**PROJECT:** Local Advanced Water Purification System

**SUBJECT:** Relocation of Reverse Osmosis Permeate Tank

Figure 1. RO Permeate Tank and Old Chlorine Contact Tank spacing needs

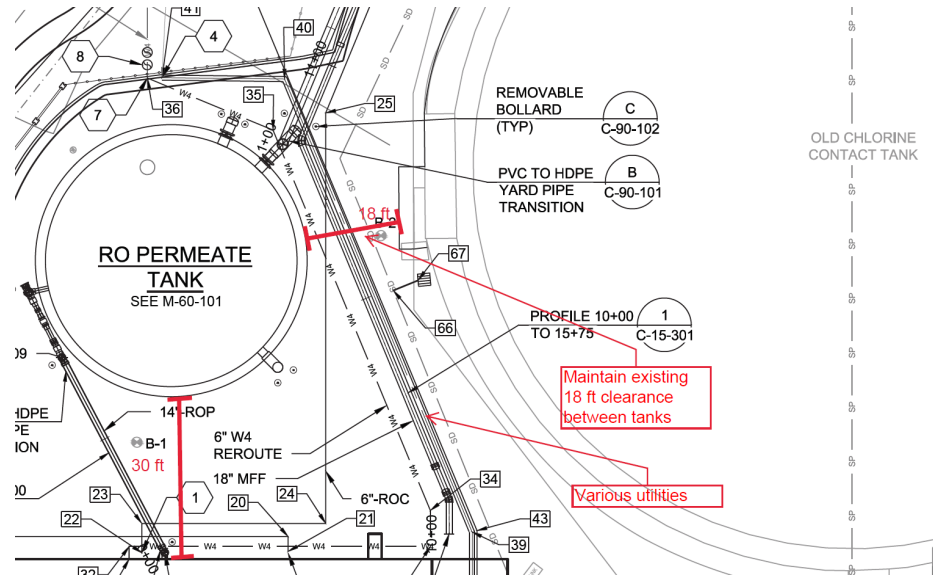
Engineering staff reviewed the design plans and existing/future facilities. Staff concluded that is not feasible to move the permeate tank towards the future Headworks building for the following reasons:

- a) The existing old chlorine contact tank will remain onsite for a few years until the new Headworks building is designed and constructed. Plant staff needs access around the old chlorine contact tank to drive trucks and equipment around it. There is an existing paved access area (18 ft wide) around the old chlorine contact tank that needs to be maintained. The proposed location for the permeate tank is such that the existing clearance is maintained. Additionally, the permeate tank manufacturers recommended maintaining 10 ft of clearance around for maintenance purposes (Figure 1).
- b) The future Headworks facility is currently in advanced planning. As such, the level of detail about the building's footprint and needs is still to be determined. Existing influent wastewater pipes run through the site and space is needed for excavation of new pipes

while maintaining existing ones in operation. Staff needs to preserve the old chlorine contact tank footprint for Headworks project needs as other Plant's facilities are contiguous to the site.

- c) The proposed Local AWPS design includes a utility corridor between the RO Permeate tank and the Old Chlorine tank. These utilities include the tertiary-treated recycled water line (feed water for the process), the final product water (permeate), the reverse osmosis concentrate line and current utilities that need to be relocated (Plant process water lines, Renzel Marsh line). Enough clearance is needed for these utilities in the existing space between tanks.

Figure 2. Chemical Delivery Truck Access

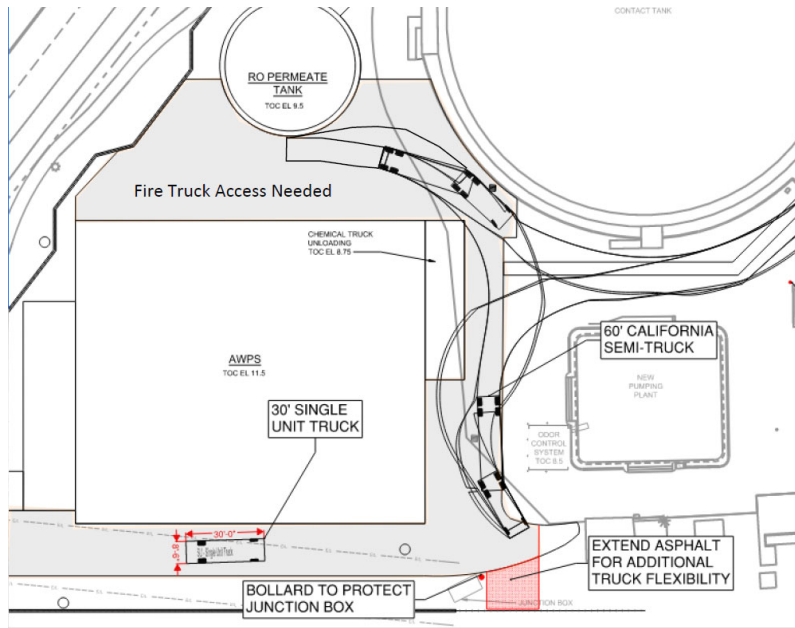
Engineering staff reviewed the design plans and future AWPS main structure. Staff concluded that is not feasible to move the permeate tank towards the new proposed AWPS structure for the following reasons:

- a) The AWPS requires the use of various chemicals and truck deliveries will occur on a frequent basis. The design engineer utilized a turning simulation software to assess the ingress/egress of a typical chemical truck on site. Due to existing site constraints and structures, the trucks will be required to back-up in the area between the permeate storage tank and the AWPS main structure. Figure 2 shows required space needs of a truck.

- b) During initial plan reviews, the City of Palo Alto Fire Department (PAFD) indicated that in case of an emergency, their vehicles should be able to access the AWPS facility from all the sides. They evaluated the available clearance between the permeate tank and the AWPS structure and requested to maintain that clearance for their trucks and equipment.
